# UNITED STATES PATENT AND TRADEMARK OFFICE

APPLICATION NO.	FILING DATE	FIRST NAMED INVENTOR	ATTORNEY DOCKET NO.	CONFIRMATION NO.
10/714,774	11/17/2003	Donald Siu	PD-200349	2413
20991	7590	09/21/2006	EXAMINER	
THE DIRECTV GROUP INC			PAYNE, DAVID C	
PATENT DOCKET ADMINISTRATION RE/R11/A109				
P O BOX 956			ART UNIT	PAPER NUMBER
EL SEGUNDO, CA 90245-0956			2613

**Office Action Summary**

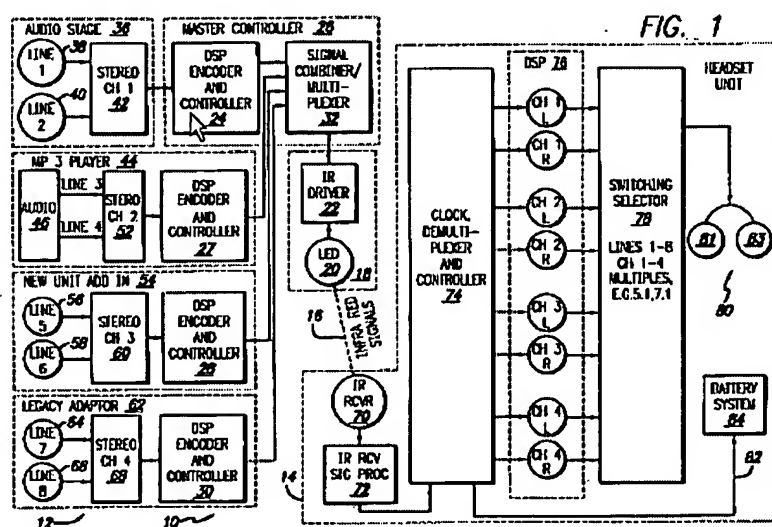
Re claims 1-3, 6-10, 12-18 Uchikubo disclosed

Next, the third embodiment of the present invention will be described with reference to FIG. 8A to FIG. 9.

The configuration of a medical apparatus supporting system in accordance with the present embodiment is the same as that shown in FIG. 1. Moreover, the configuration shown in FIG. 8A corresponds to the configuration of the medical apparatus supporting system shown in FIG. 2.

A medical apparatus supporting system 41 shown in FIG. 8A consists mainly of medical equipment 2 having a communication facility and a remote control computer 4 linked to the medical equipment 2 over a communication line 5 over which information is transmitted.

The medical apparatus supporting system 41 includes a plurality of program storage means in which a program for instructing the medical equipment 2 how to act is stored, or more particularly, two ROMs 6-1 and 6-2 as shown in FIG. 8A.

The medical equipment 2 includes a CPU 42 connected to a communication interface 7 and the two ROMs 6-1 and 6-2. The CPU 42 controls the actions of the medical equipment 2 according to the program stored in the ROM 6-1 or ROM 6-2. The programs stored in the ROM 6-1 and ROM 6-2 are rewritten under control of the

CPU 42. The ROM 6-1 and ROM 6-2 are realized with, for example, nonvolatile electrically reprogrammable EEPROMs (or flash memories).

The remote control computer 4 includes an interface 9 connected to the communication line 5 and a CPU 43 connected to a program storage means (hard disk) 11 in which a rewriting program is stored. The CPU 43 controls transmission of the program used to rewrite an old program. An operation program for instructing the CPU 43 how to act is also stored in the hard disk 11.

According to the present embodiment, at least two memory means are included as memory means in which a program to be transmitted is stored. Even if transmission of data over the communication line 5 is not performed smoothly a program can be rewritten reliably, col./line(s): 10/10-45.

FIGURE 9A

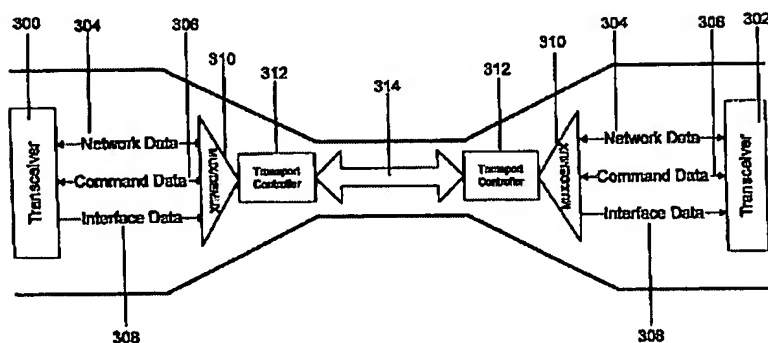
Re claims 1, 2, 4-9, 11-17, 19, 20, **Milley** disclosed

The present invention is directed to methods and apparatuses for wireless network computing where the collaboration of two or more devices provides functionality not possible from a single device. The methods disclosed herein may be implemented in cellular phones, PDAs, handheld computers and other mobile devices and allow users to wirelessly control other devices capable of displaying full Internet content. In particular, the invention is directed to wireless Internet computing using remote display devices and handheld computers, e.g., paragraph 21.

For all of the above data flow scenarios shown in FIGS. 9A to 9E the flow is bi-directional. Thus the three transmitted data streams (304, 306, 308) from the first transceiver (300) sent to the second transceiver (302) undergo the same process as if the three data streams were transmitted by the second transceiver (302) to the first transceiver (300). On the system block diagram shown in FIG. 1B, the transceivers (22,40) are the same transceivers as shown in FIGS. 9A-9E (300, 302); thus the transport systems (52, 54) are the combinations of multiplexers/demultiplexers (310, 316) and transport controllers (312), and the medium (56) carries all of the signals (314, 318, 320, 322, 324, 326, 328, 330, 332, 334) e.g., paragraph 113.

A transport controller (312) can be several layers of software, an implementation in hardware/firmware, or a combination of the two. The transport controller (312) packages, assembles, modulates and transmits data. The controller will also receive, demodulate, unpack and disassemble received data to recover information transmitted by the other device. The packaging and assembly process will involve any or all of

formatting, compressing, digital signing, encrypting, and the addition of error correction. The unpacking and disassembly process will retrieve the original transmitted information by error correcting, verifying, decrypting, uncompressing, and restoring the received data as necessary. The transport controller (312) also filters out received data, which is not part of the method or part of the communication between devices. In addition to the above, the transport controller (312) would also control the connection between two or more devices, including link loss, and other characteristics. It is also possible that the transport controller (312) will not modify the data at all, e.g., paragraph 114.

A multiplexer/demultiplexer (310, 316) could be any device, implemented in software, hardware, or a combination of software and hardware that combines (multiplexes) multiple input streams of information to produce fewer output streams of information. Multiplexed streams can be separated (demultiplexed) to obtain the original streams of information. An example of software multiplexers (310, 316) is the GSM TS 07.10 standard, of which a subset is used in the Bluetooth protocol, e.g., paragraph 115.
